Item ID: D412-664-105

Item Name: Crosstube, Low Narrow Fwd, 412CF

DRAWING NO. D412-664-145		TITLE CROSSTUBE ASS'Y (412 LOW-N FWD)		REV. D	DART AEROSPACE LTD ENGINEERING ORDER		D.E.O. NO. D412-664-145-D-1	SHEET NO. SHEET 1 OF 2	SCALE NTS
DRAWN <i>q</i>		CHECKED <i>sc</i>		MFG. APPR. <i>R</i>		APPROVED <i>MD</i>		DE APPR. <i>MD</i>	
DATE 11.05.25		DATE 11.05.31		DATE 11.05.31		DATE 11/25/31		DATE 11.05.31

FIGURE 1: SUPPORT INSTALLATION

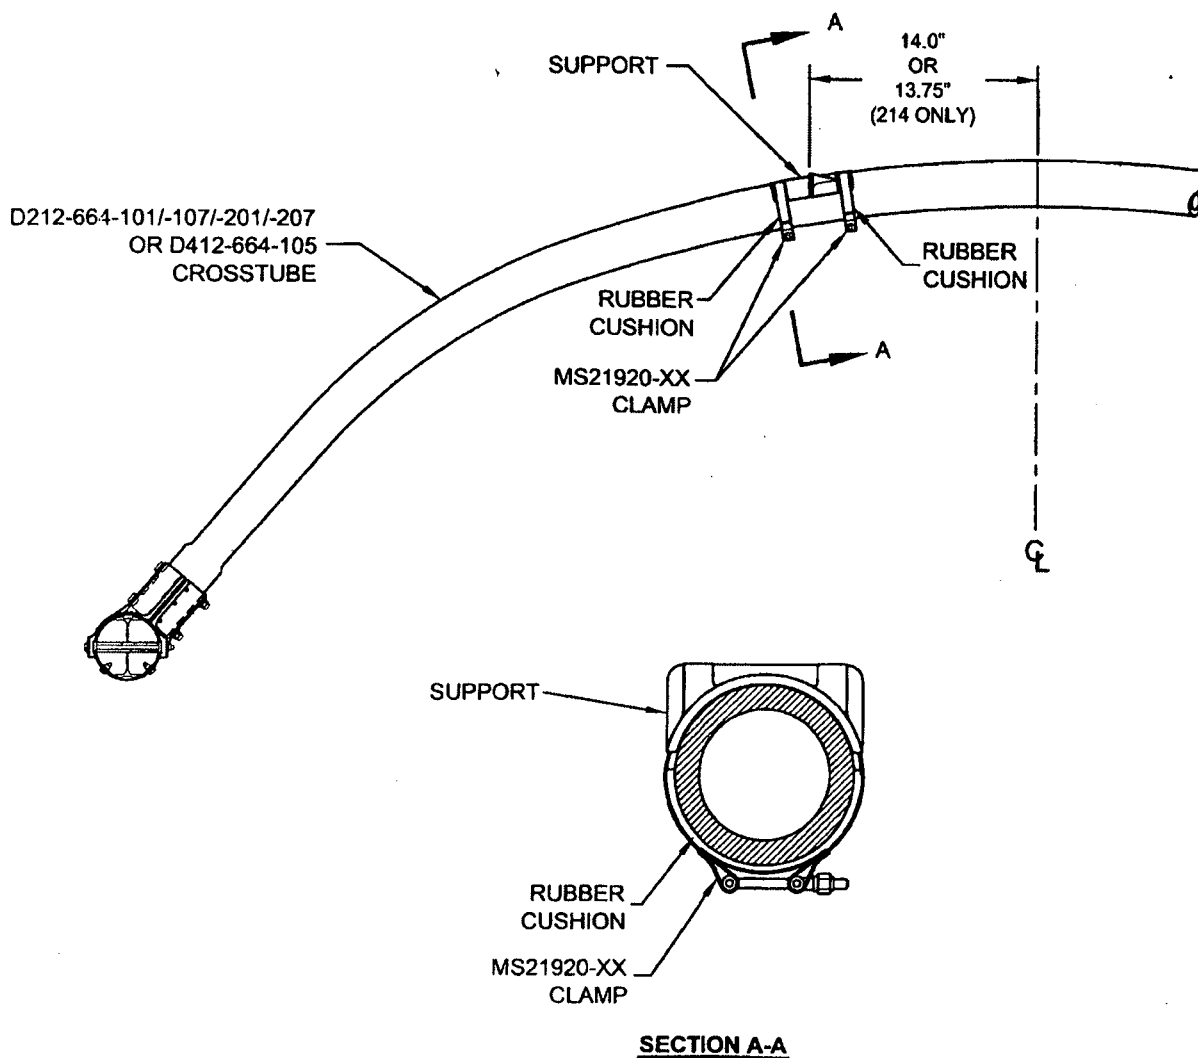
For the crosstubes listed above, section 32.4 of ICA-D212-664 is amended as follows. Use Figure 1 of this service instruction and Figures 32-2 to 32-9 of ICA-D212-664 for further reference. For crosstubes of an earlier change number, it is recommended that if the supports are removed, the supports should be reinstalled using the procedure listed below.

- 32.4.1 Locate the area on the crosstube for installation of support (see Figure 1 of this service instruction). For D212-664-101/-107/-201/-207 and D412-664-105 crosstubes, the outward face of the support tabs should be 14.0" (355mm) from the crosstube center for 204/205/210/412/UH-1 aircraft. For installation on 214B/B-1 aircraft, the outward face of the support tabs should be 13.75" (349mm). Ensure paint finish of crosstube is intact; touch up as required per Chapter 5 (5.3.9) of ICA-D212-664.

- 32.4.5 Apply a 0.04" to 0.07" thick layer of Proseal 890 Class B or AMS-S-8802 Class B sealant underneath applicable support and install support as shown in Figure 1 of this service instruction.

- 32.4.6 Install the clamps opposite to crosstube support as shown in section A-A of Figure 1. Install rubber cushions underneath each clamp around the bottom circumference of the crosstube up to the crosstube centerline. Torque clamps 80-100 in-lb (9.0-11.3 Nm). It is acceptable to use smaller or larger sized MS21920-XX clamps than those listed in ICA-D212-664, ensure that after torquing the clamps per this instruction, the nuts are in safety but not bottomed out

**D412-664-145
ASSEMBLY DETAIL**

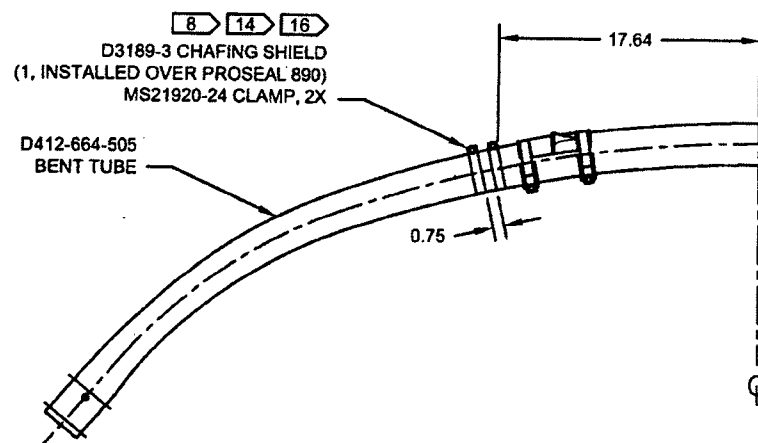
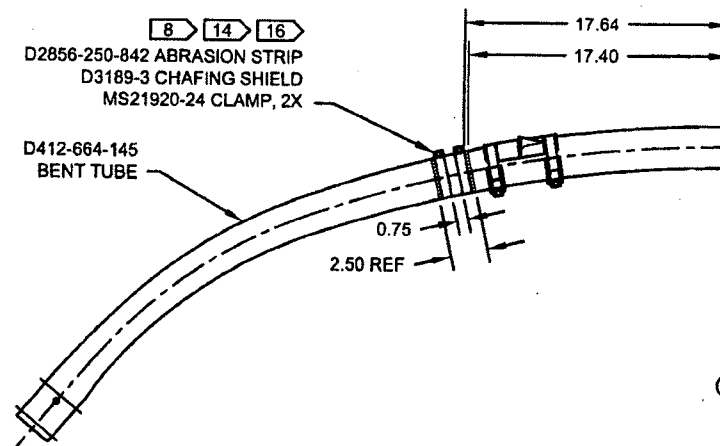
NOTE 14, SHEET 1 IS AMENDED AS FOLLOWS:

**D412-664-145
ASSEMBLY DETAIL**

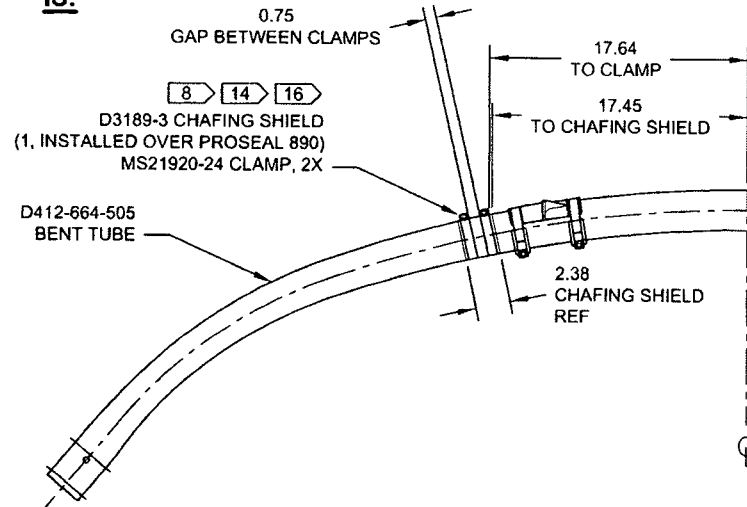
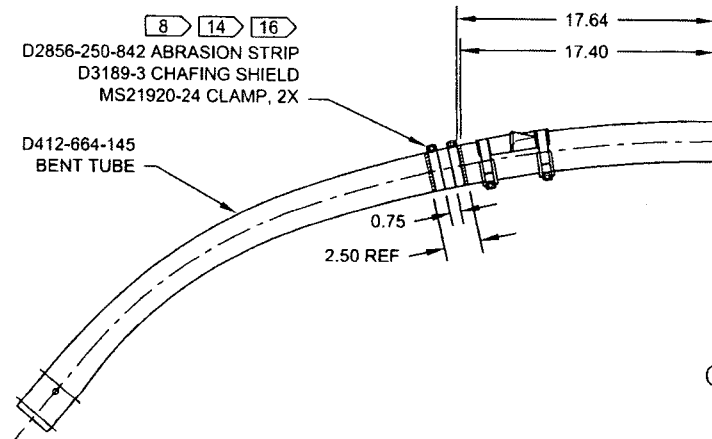
NOTE 14 AND 16 ON SHEET 1 IS AMENDED AS FOLLOWS:
